Access Compliance Report Public Rights-of-Way (Curb Ramps)

Main Street: WALLINGSFORD_RD Cross Street: WIMBLETON_DR Location: SW

ADA ID: RPRK211215144119 Ramp Type: Type 1 - Perpendicular Diagonal Initial Pass/Fail: Fail Overall Compliance: No Severity Score: 16

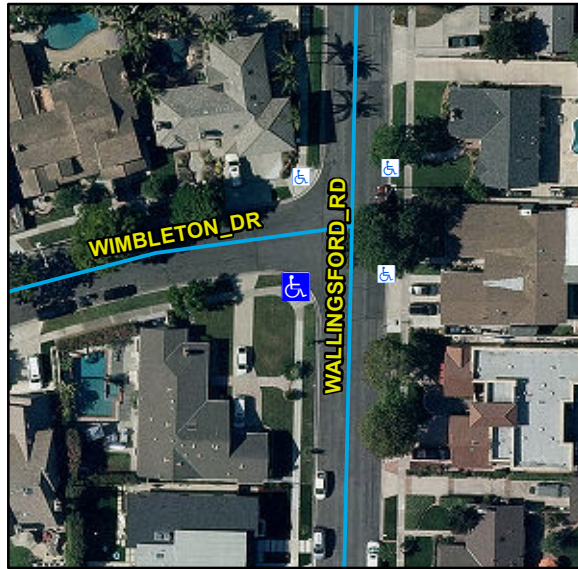
Compliance	Description	Data	Compliance	Description	Data
N/A	Ramp Length (in)	79	N/A	Flare Type LT	
Yes	Ramp Width (in)	48			N/A
No	Ramp Run Slope (%)	8.6	N/A	Flare Slope LT (%)	N/A
No	Ramp Cross Slope (%)	2.1	N/A	Flare Traversable LT	N/A
N/A	Landing Present	N/A	N/A	Flare Type RT	
N/A	Landing Length (in)	N/A			N/A
N/A	Landing Width (in)	N/A	N/A	Flare Slope RT (%)	N/A
N/A	Landing Run Slope (%)	N/A	N/A	Flare Traversable RT	N/A
N/A	Landing Cross Slope (%)	N/A	N/A	DWS Provided	N/A
N/A	Landing Movement Obstructed?	N/A	N/A	DWS Contrast	N/A
	Landing Movement Type	N/A	N/A	DWS Length (in)	N/A
N/A	Landing Shared	N/A	N/A	DWS Full Width	N/A
N/A	Clear Space	Yes	N/A	DWS Offset Left (in)	N/A
N/A	Clear Space To Crosswalk (in)	N/A	N/A	DWS Offset Right (in)	N/A
N/A	Marked Crosswalk 1	No	N/A	Marked Crosswalk 2	No
	Crossing 1 Direction	E		Crossing 2 Direction	N
	Marked Crosswalk 1 Width (in)	N/A		Marked Crosswalk 2 Width (in)	N/A

N/A	Ramp Inside Crosswalk 1	N/A	Yes	Ramp Inside Crosswalk 2	N/A
	Crossing 1 Slope (%)	4.8		Crossing 2 Slope (%)	7.9
	Crossing 1 Cross Slope (%)	3.9		Crossing 2 Cross Slope (%)	1.9
N/A	Gutter Ponding	N/A	N/A	Curb Slope	3.4
Yes	Gutter Lip Height (in)	0		Road Run Slope (%)	1.3
N/A	Gutter Run Slope (%)	N/A		Road Cross Slope (%)	9.7
N/A	Gutter Cross Slope (%)	N/A			
Yes	Overall Surface Condition: Acceptable		No	Perp Joint Present	No
	Cross Gutter Present?	No		Spandrel Present?	No
	Replace Cross Gutter?	N/A		Replace Spandrel?	N/A

Remove & Replace Curb Ramp With Two New Directional Ramps or Equivalent.
